10/524,710

Office Action Summary	Application No. 10/524,710	Applicant(s) MANABE, KATSUNORI	
	Examiner Michelle Lopez	Art Unit 3721

Claims 1 and 3-4 are rejected under 35 U.S.C. 102(b) as being anticipated by Kuhns 6,071,053.

Ohmae's Fig. 4.

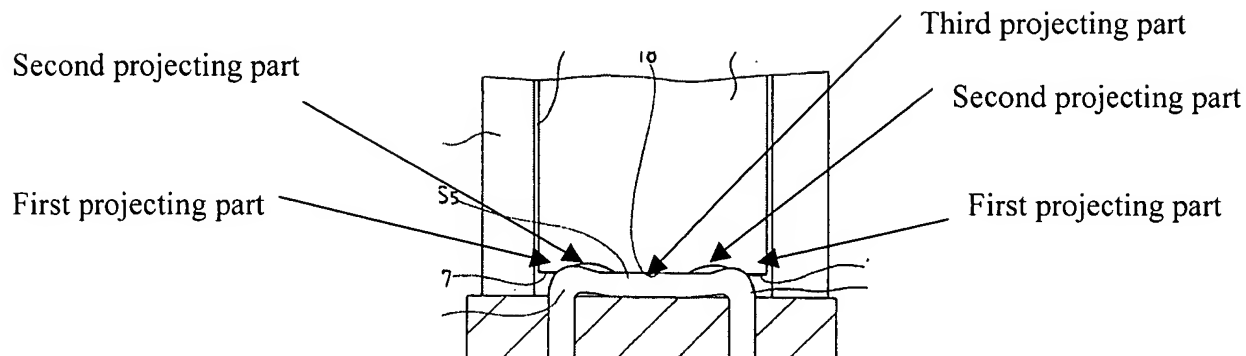
Claims 1 and 3-4 are rejected under 35 U.S.C. 102(b) as being anticipated by Ohmae 5,941,440.

Ohmae discloses a driver structure for a stapler comprising a blade edge disposed to be in contact with a staple, first projecting parts 17,19 provided at opposite end portions of the blade edge and disposed to be in contact with a corner formed between the crown and each leg portion of the staple as shown in Fig. 4 for pressing the leg portions, and second projecting parts having a curved shape between the first projecting parts 17,19 and 18 and configured to be in contact with the crown, wherein the second projecting parts has a corner portion which engages with the crown as shown in Fig. 4.

With respect to claim 3, Ohmae discloses a third projecting part provided between the second projecting parts to hold the crown of the staple when the pair of leg portions pass through the bundle of papers.

With respect to claim 4, Ohmae discloses wherein the third projecting part comprises a crown pressing portion to press the crown.
